Project	The Falls on Refugee Road	Addendum Number	3
Project Number	23446	Date	07/10/2025
To	All Bidders

This addendum contains changes to the requirements of the bidding Documents, Project Manual and Construction Drawings which have been issued to date. Such changes are to be incorporated into the Construction Documents and shall apply to the work in the same meaning and force as if they had been included in the original documents. Wherever this Addendum modifies a portion of a paragraph of the Project Manual or a portion of any Drawing, the remainder of the paragraph or Drawing shall remain in force.

05/01/2025
23446
C216
CD PROGRESS SET

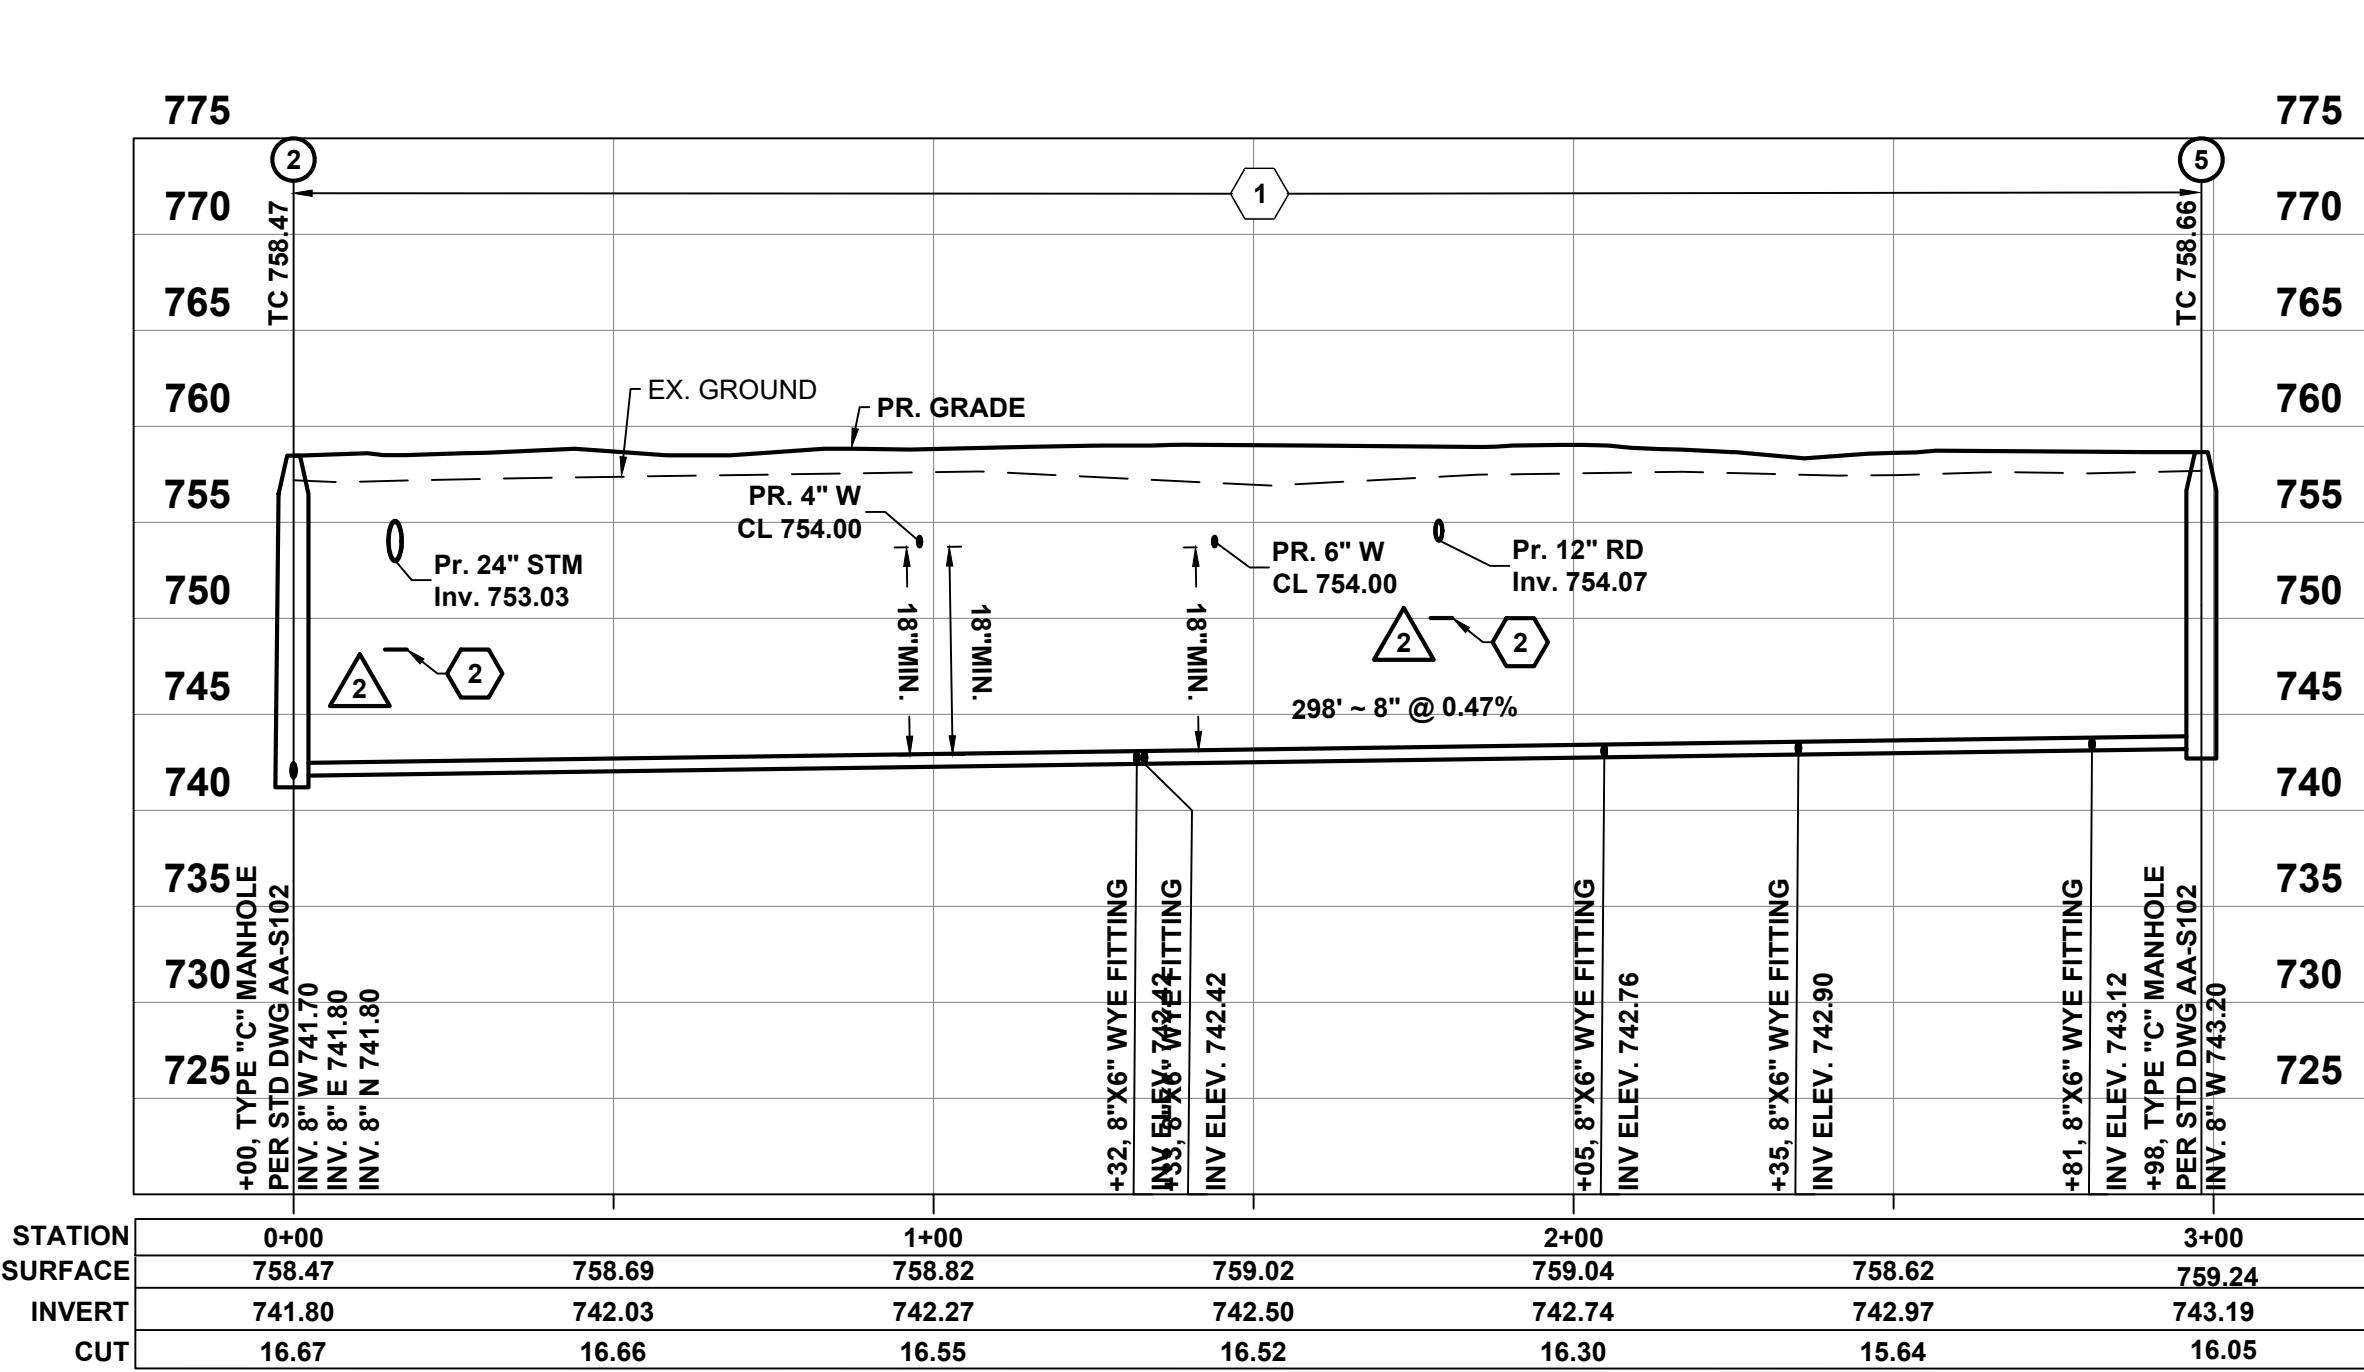
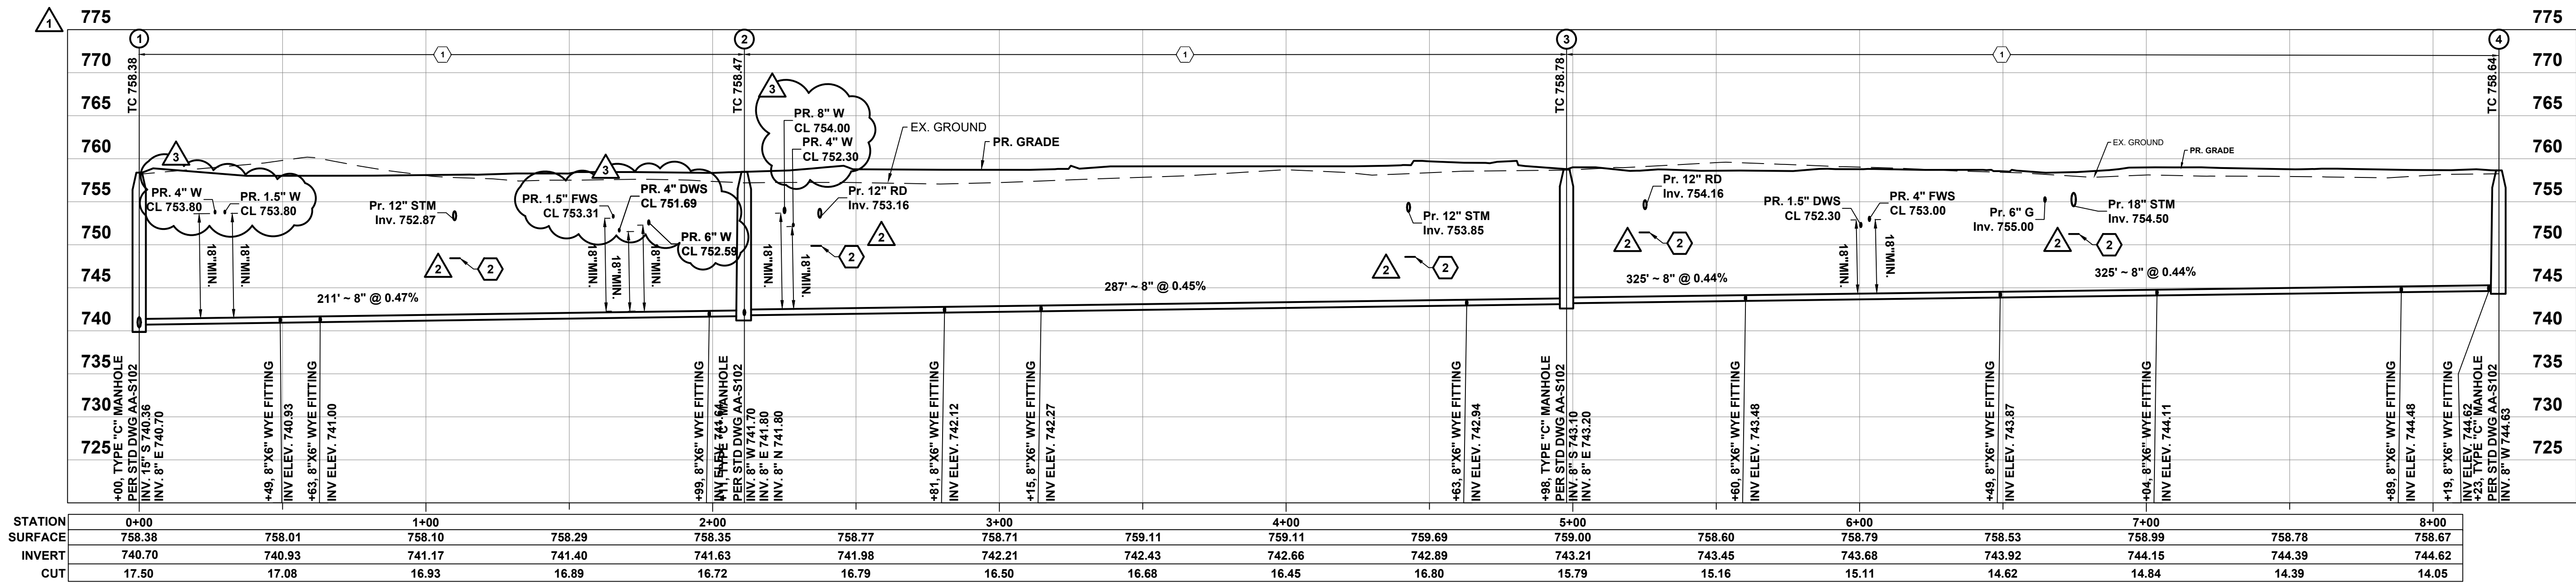
13. SHEET C216 – STORM SEWER PROFILES
 - A. **ADD** roof drain inverts to structures 32, 41, and 45 in profile.
 - B. **ADD** compacted fill area per item 203.
